**VILLAGE OF ALGONQUIN
PLANNING AND ZONING COMMISSION
AGENDA**

SUBJECT: *Case No. 2019-15. 2621 Corporate Parkway — Final Planned Unit Development*

Subject: 2621 Corporate Parkway – FIRST REVIEW
Algonquin Case No. 2019-15
(CBBEL Project No. 07-0272.00118)

DATE: September 27, 2019
TO: Ben Mason, Senior Planner Village of Algonquin
FROM: Cory Pikora, Fire Prevention Director Algonquin- LITH FPD
RE: 2019-15 Final PUD 2621 Corporate Parkway

NORTH ELEVATION

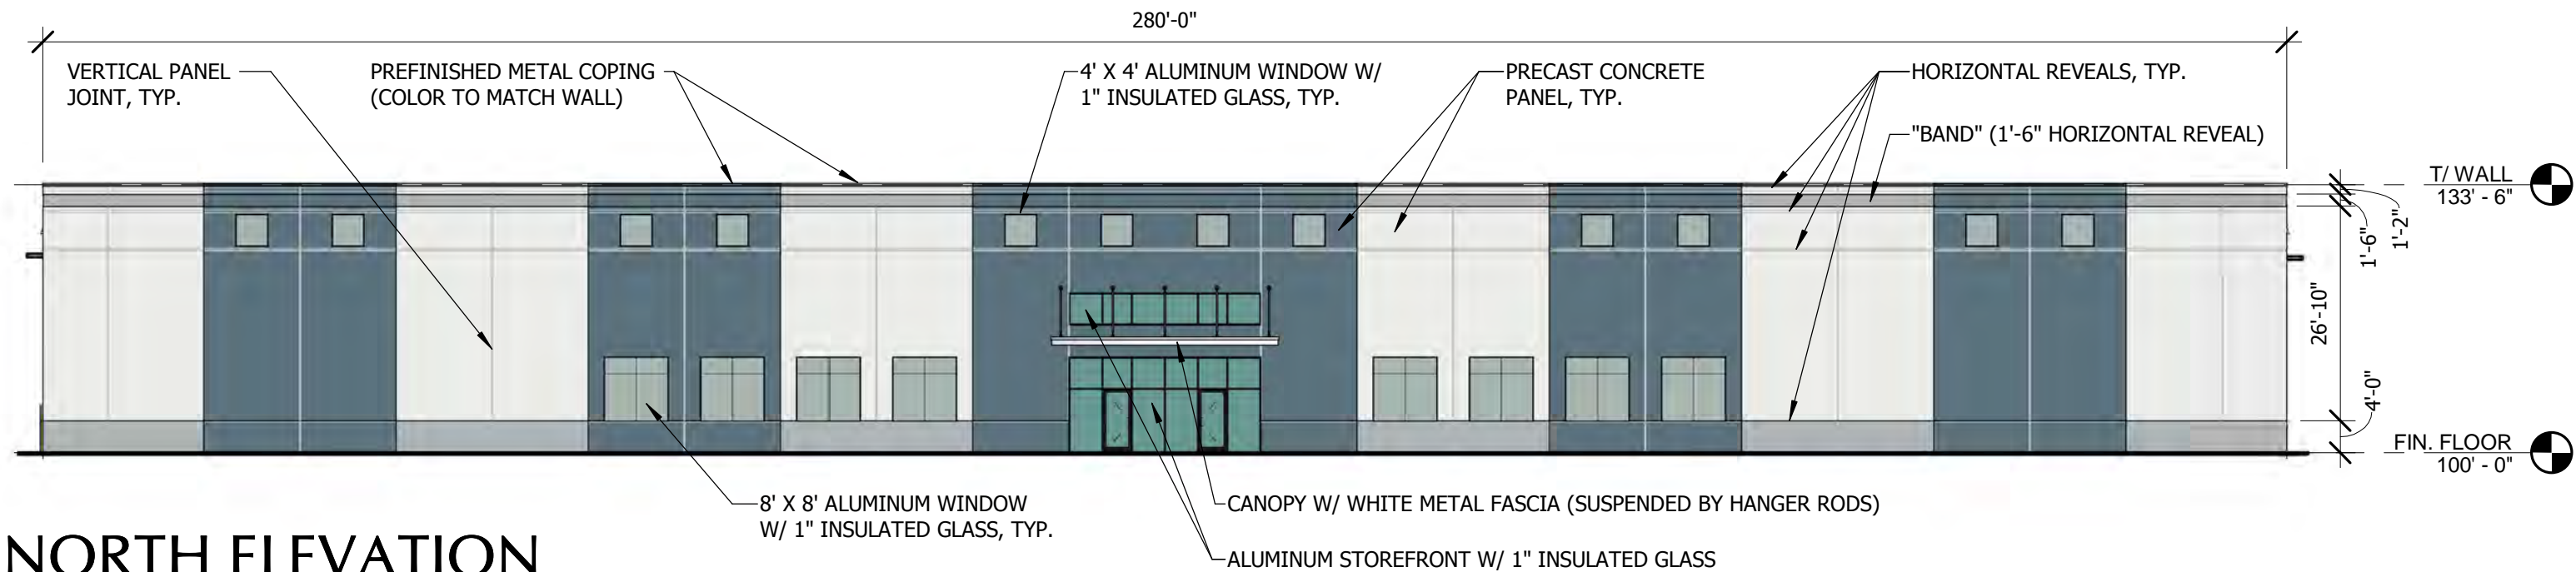
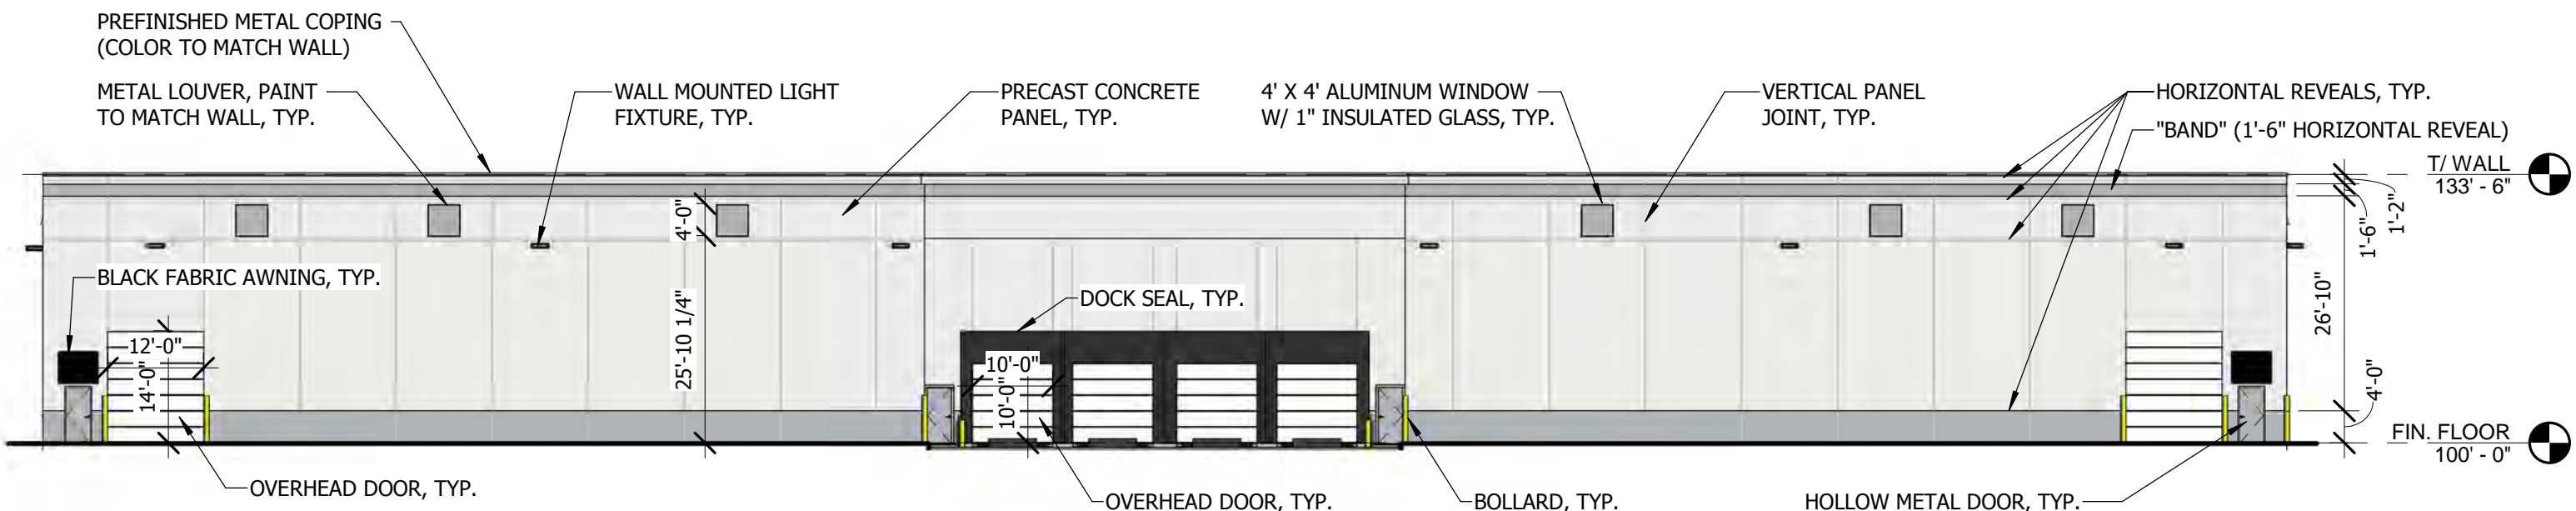
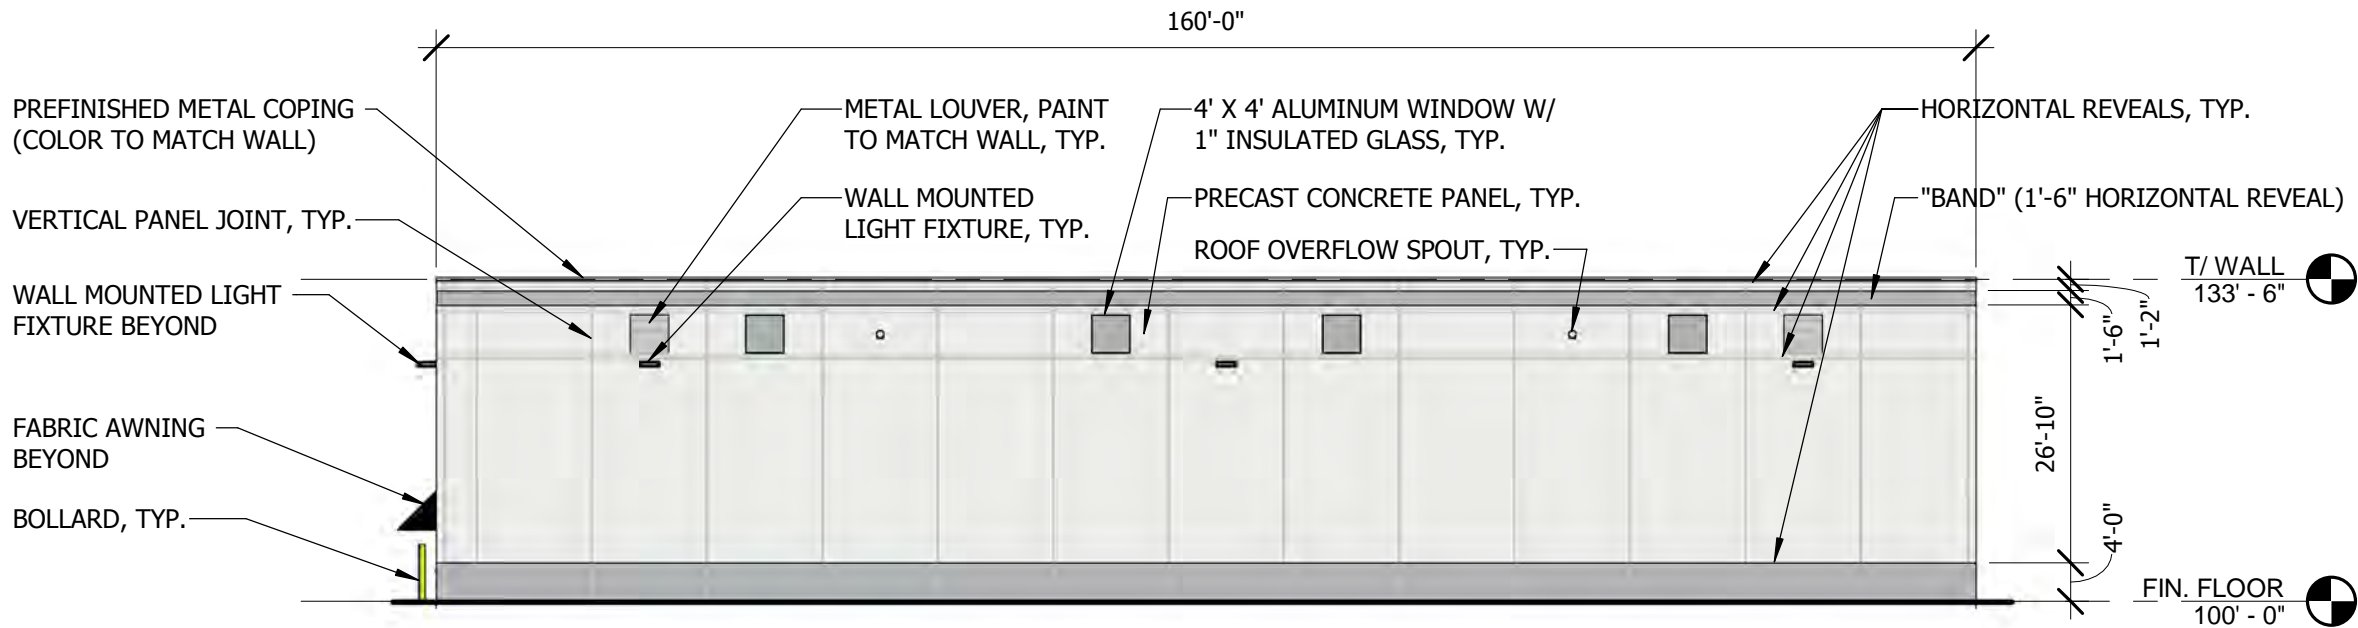
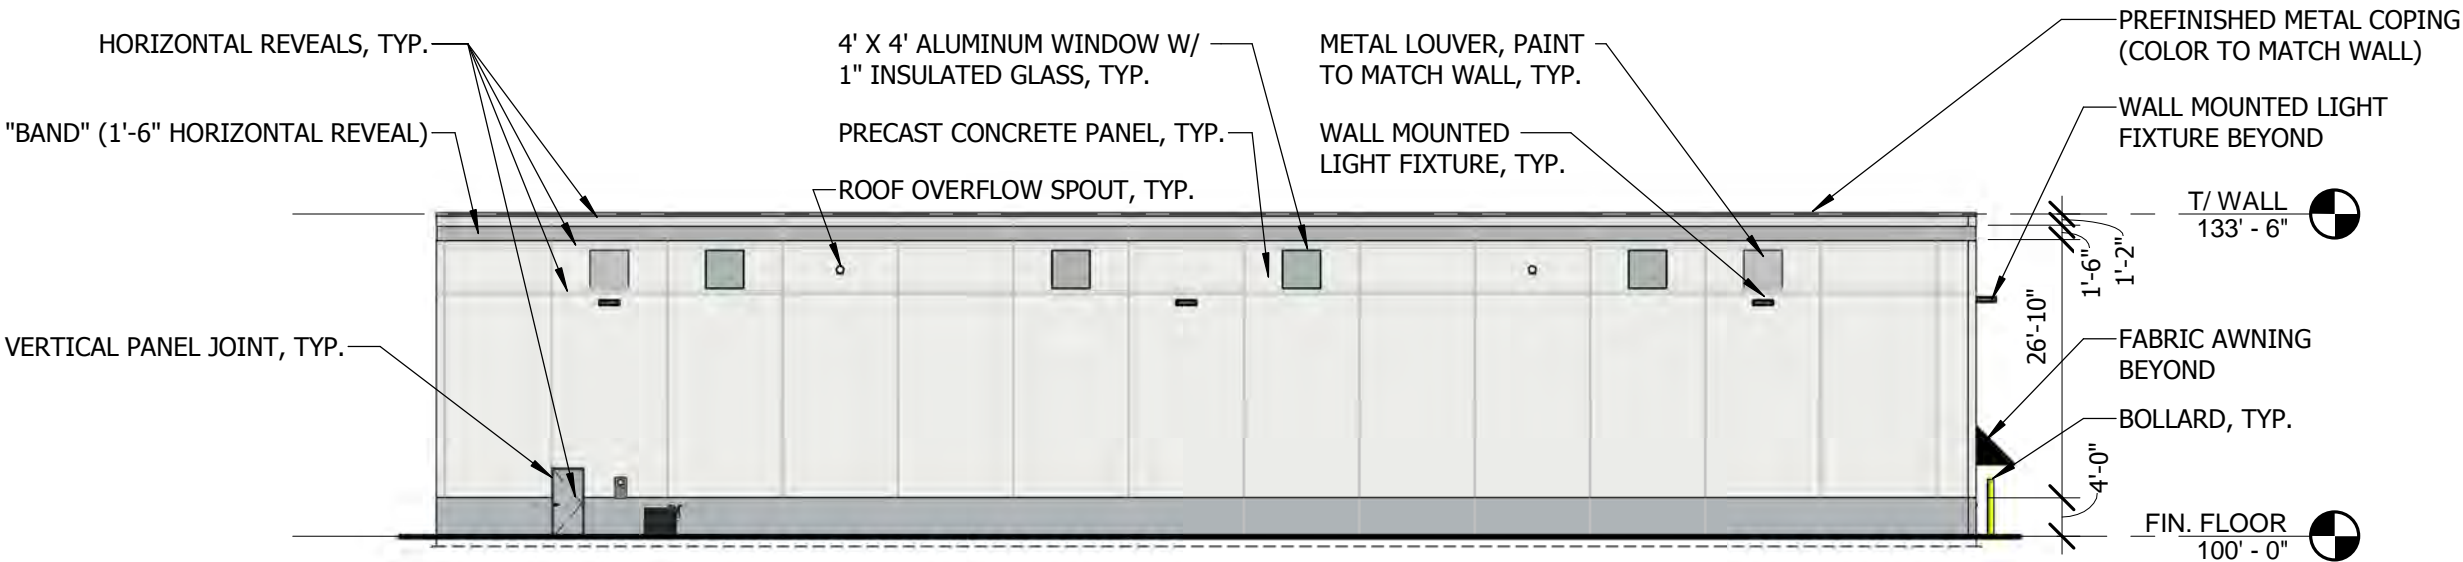
Architecture / Building – The warehouse building will be constructed of precast concrete panels and the main field of the building will alternate between off-white and muted-blue color tones. To provide additional architectural interest, the same alternating color palette of off-white and blue precast panels proposed for the front façade shall be continued around the sides and rear of the building as well. All mechanical equipment and utility meters shall be screened from view or painted to match the building. The buildings’ window framing system shall be black or a dark bronze.

5. The building shall be constructed to be consistent with the architectural elevations as prepared by DDCA Architects, with the latest revision date of October 9, 2019. To provide additional architectural interest, the same alternating color palette of off-white and blue precast panels proposed for the front façade shall be continued around the sides and rear of the building as well. In addition, all mechanical equipment and utility meters shall be screened from view or painted to match the building. The buildings' window framing system shall be black or a dark bronze. Should the current or future owner of the building

Algonquin Corporate Campus Lot #2
Algonquin, IL
Landscape Plan

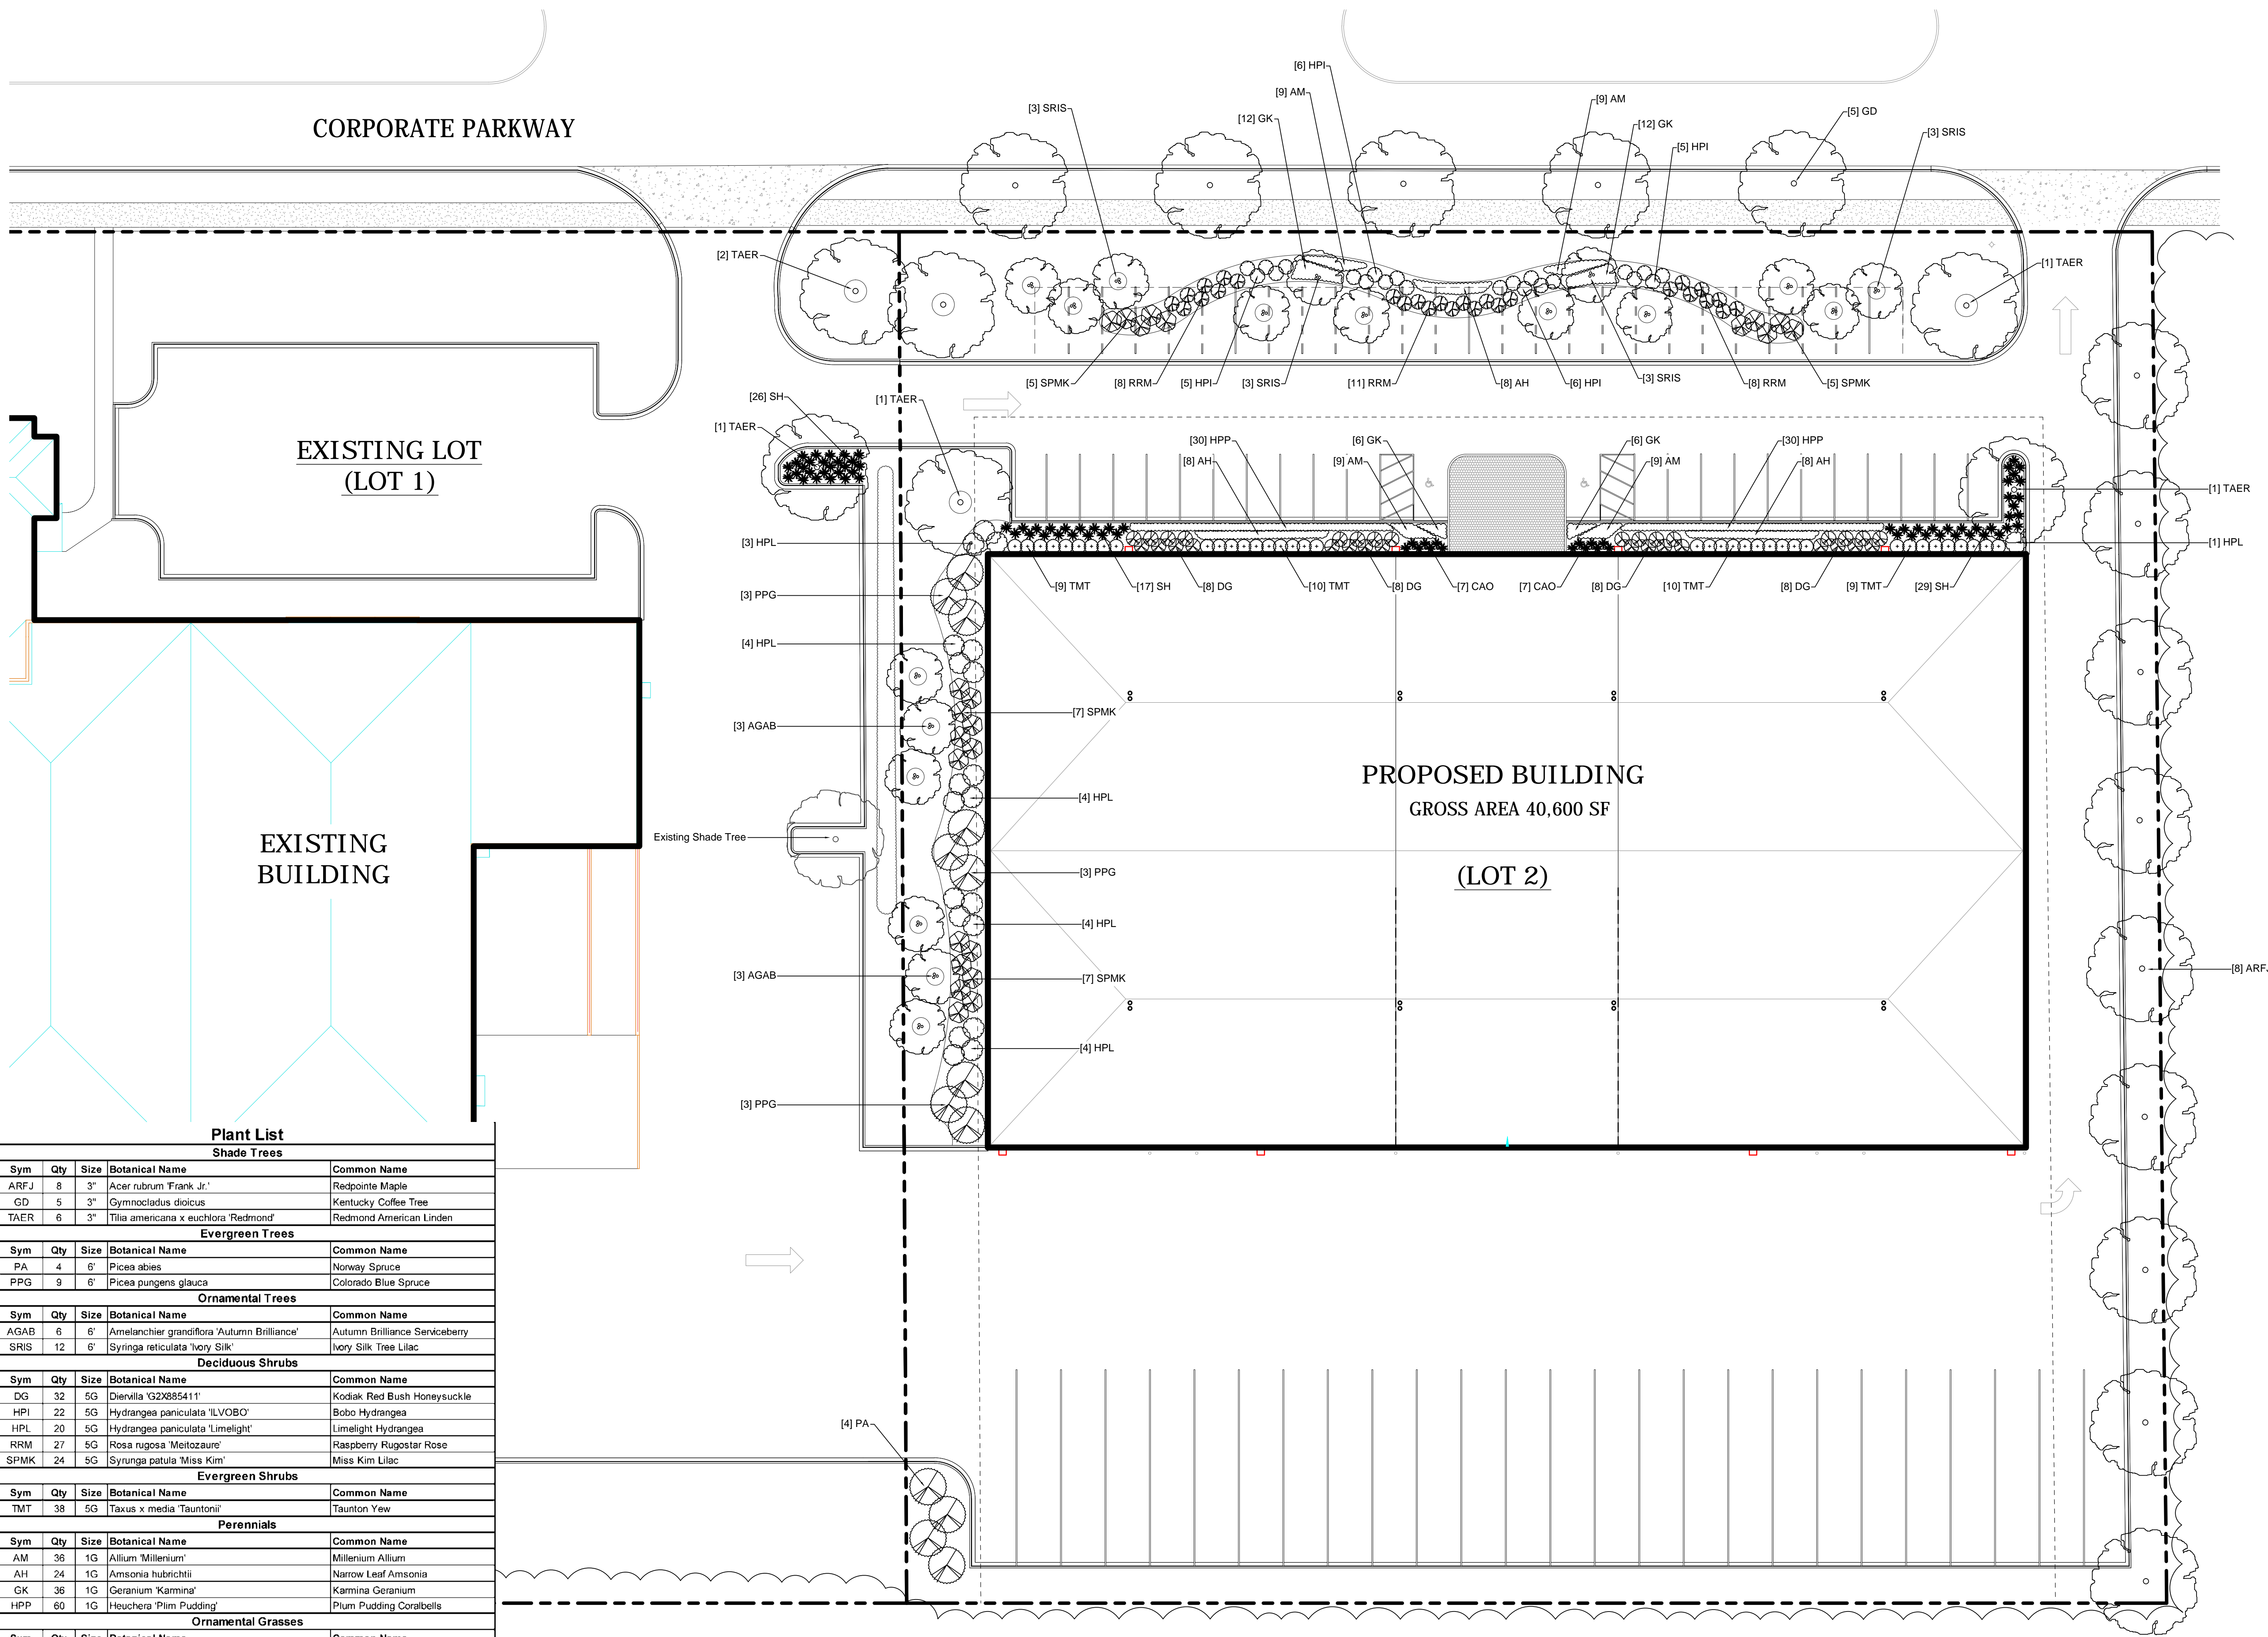
14. The locations of all proposed pole-mounted lighting and underground utilities shall be added to the plan sheet to verify no conflicts exist with the proposed trees.
15. We note that the landscaping of the boulevard medians to the west and east of the site is more elaborate and lush than the median in front of the development

site. We will defer to the opinion of the Public Works staff, but this appears to be an opportunity to add more trees and shrubs to the median if so desired.

16. The existing trees in the south parkway of Corporate Parkway are missing from the plan sheet. We note that new trees are called out for the parkway. The plans should identify if the existing trees are to be removed or relocated.

In light of the fact a significant portion of the front landscape setback along Corporate Parkway is proposed for conversion to additional parking if / when needed in the future, Village Staff recommends the installation of a dense row of arborvitae shrubs or similar landscape screening treatment in the 15-foot area that would not be disturbed directly adjacent to and south of the sidewalk.
